CASE NO. FP-2024-0017

ORDER OF CONDITIONAL
APPROVAL OF FINAL PLAT

STAFF REPORT
COMMUNITY DEVELOPMENT DEPARTMENT

HEARING DATE: 09/10/2024
TO: Mayor & City Council
FROM: Nick Napoli, Associate Planner
208-884-5533
SUBJECT: Apex Northwest No. 5
FP-2024-0017
LOCATION: Near the northwest corner of S. Locust
Grove Rd. & E. Lake Hazel Rd., in the
SE ¼ of Section 31, Township 3N.,
Range 1E.

B. Final Plat (dated: 05/29/24)

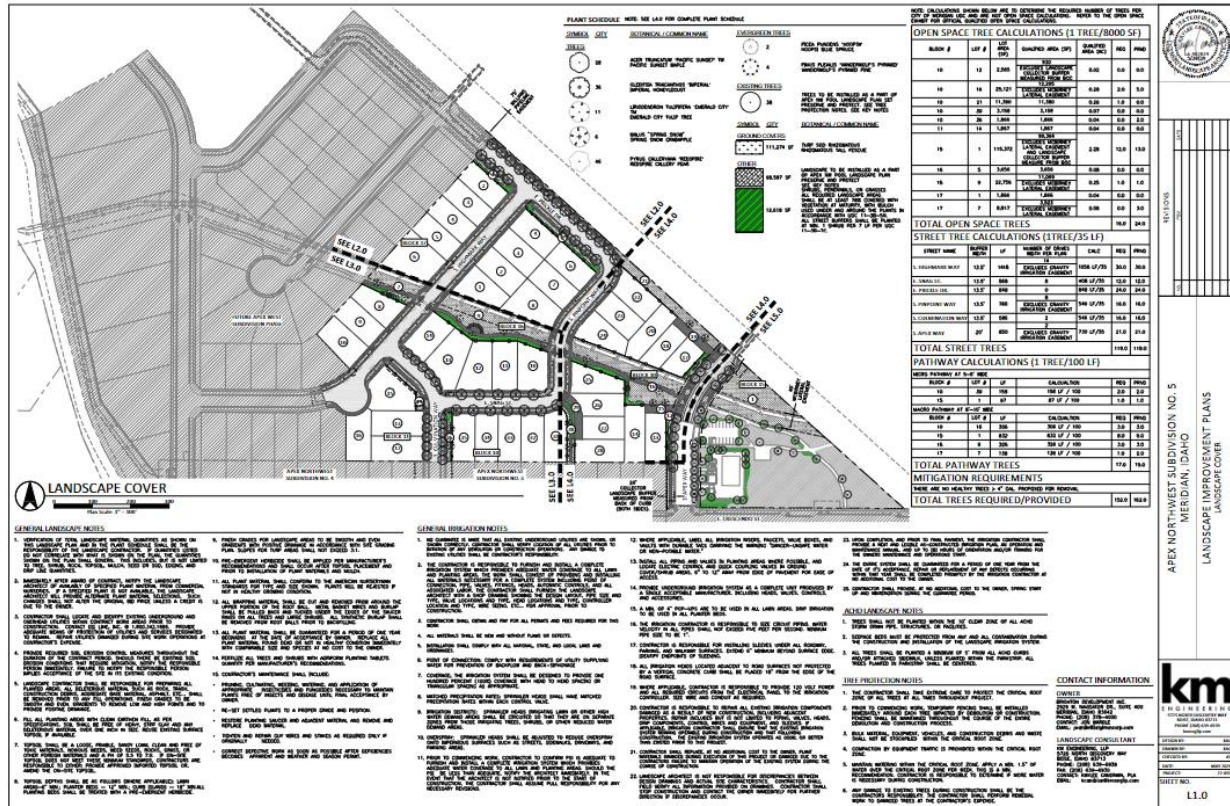
- c. Note #16: Include the recorded instrument number of the City of Meridian Sanitary Sewer and Water Easement.
 - d. Lot 15, Block 10 shall be extended through Lot 14, Block 10 and Lot 19, Block 10 shall be extended through Lot 20, Block 10 to depict identical building setback envelopes shown on adjacent properties. The intent behind this is to prevent residents from backing down the common lot out of their garage. Please depict on an updated common drive exhibit.

- e. Replace the street name for “S. Highmark Way” with “S. Highmark Avenue” in accordance with the Ada County Street Name Review.
A copy of the revised plat shall be submitted with the final plat for City Engineer signature.
